TOLEDO - LUCAS COUNTY PLAN COMMISSIONS

REF: SUP-9007-22

SUBJECT: Special Use Permit for Community Recreation-Active, for soccer field expansion at 2610 Schneider Road and 0 S. Detroit Avenue (Parcel 18-08510)

SITE PLAN

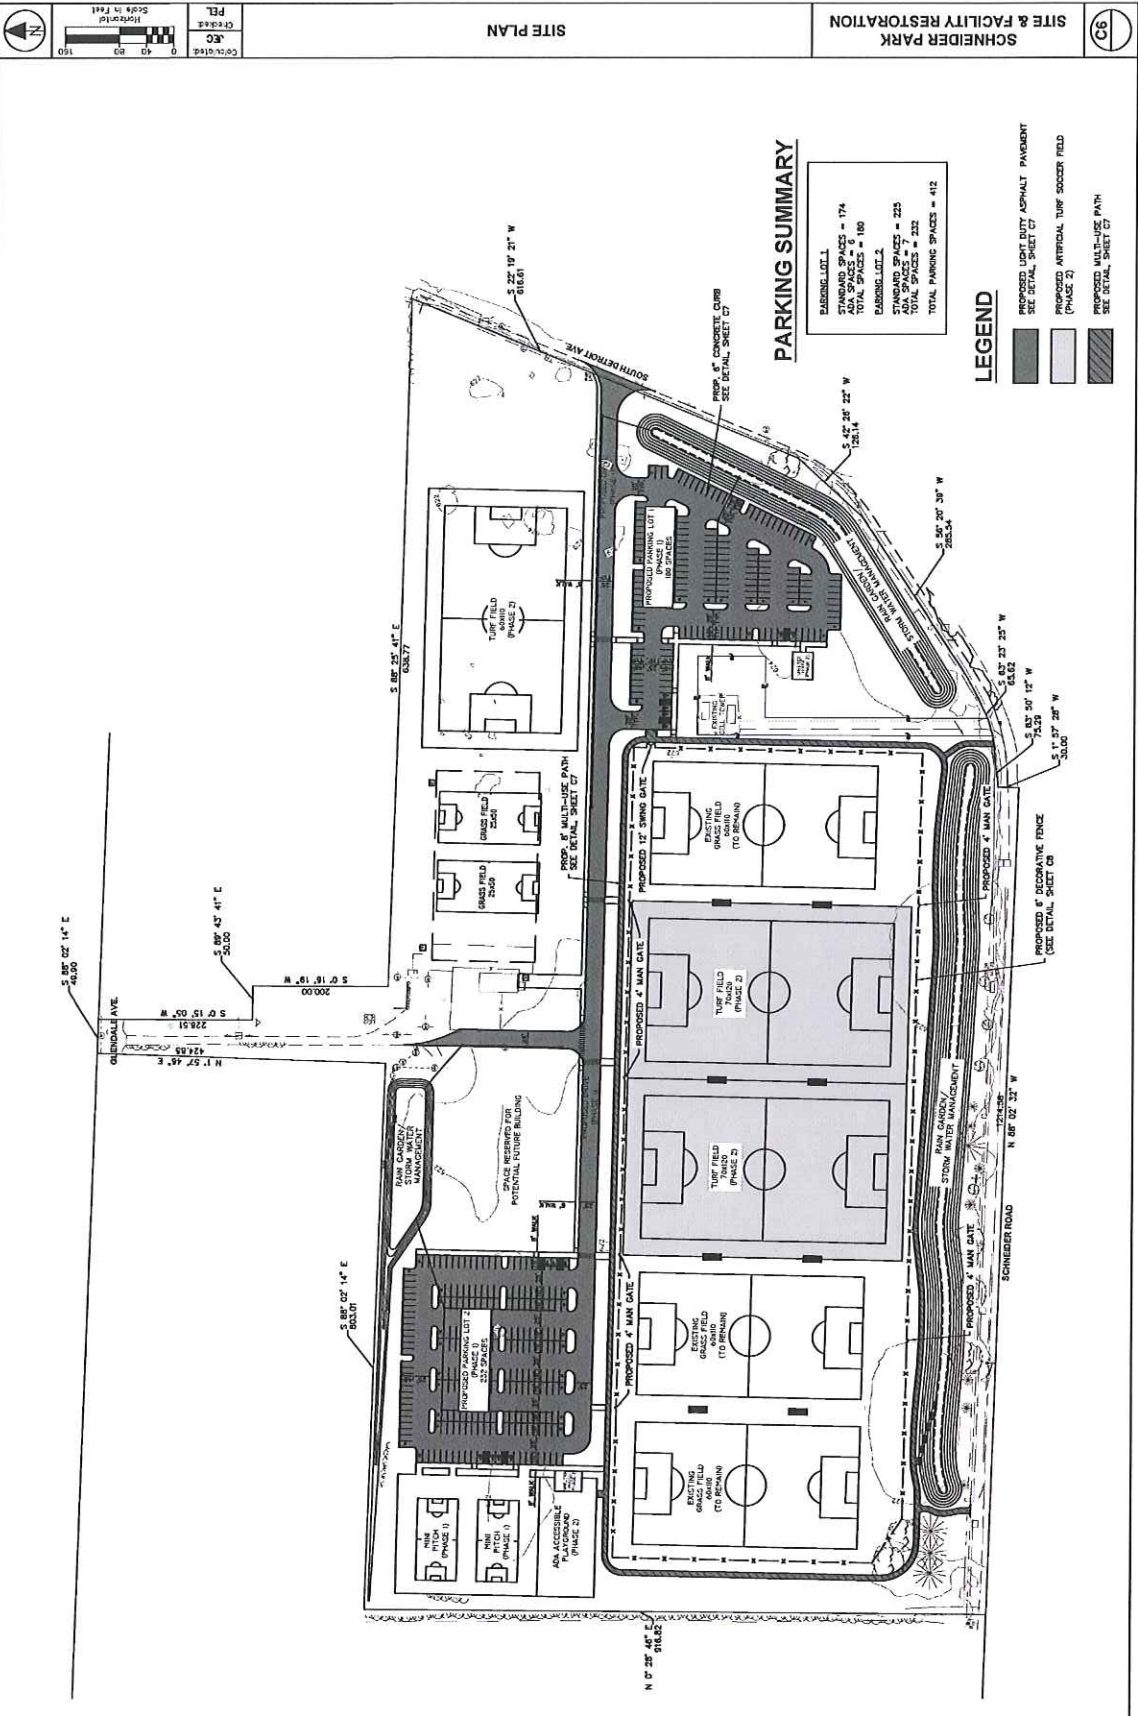
23. Per TMC§1107.0400, Off-Street Parking Schedule “A” requires one (1) bicycle parking slot per ten (10) parking spaces. **Not acceptable as depicted. Forty-one (41) spaces are required.** Applicant is encouraged to distribute bicycle parking in such a manner as to be accessible for all fields.

24. A sidewalk connecting Glendale Avenue to the site parallel to the driveway shall be included on a revised site plan. **Not acceptable as depicted.**

LANDSCAPE PLAN

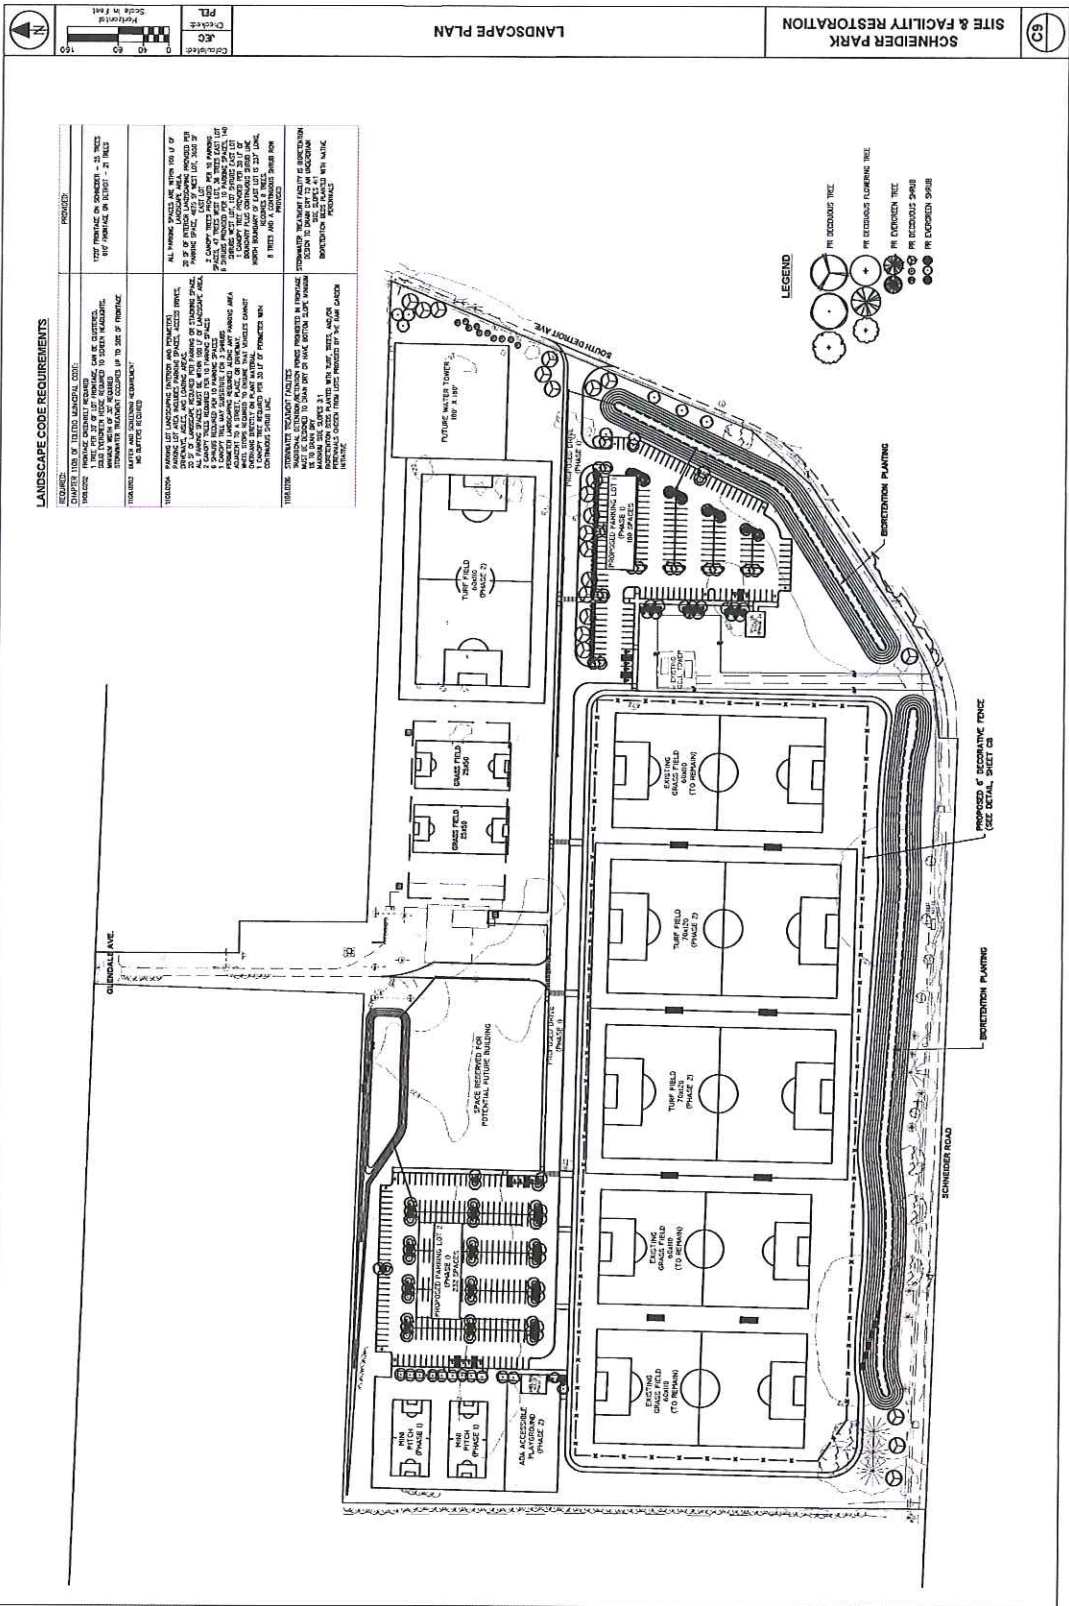
- a. A thirty-foot (20') greenbelt is required along Schneider and Detroit and shall include one (1) tree per every thirty feet (30') of frontage. Trees are not required to be evenly spaced and may be clustered. **Not acceptable as depicted. Thirty (30) additional trees are required along Schneider.**

- b. Perimeter landscaping must be installed along any parking lot area adjacent to a street, place, or driveway, or which is visible from an immediately adjacent property, and must include a continuous shrub row with a minimum height eighteen inches (18"). **Not acceptable as depicted: Additional shrubs required along the eastern and southern portion of Lot 1 and the northern portion of Lot 2.**

- i. Bioretention filter beds must be planted with turf, trees, and/or perennial plant material chosen from lists provided by the Rain Garden Initiative. **Mulch shown, plantings shall be added on revised landscape plan.**
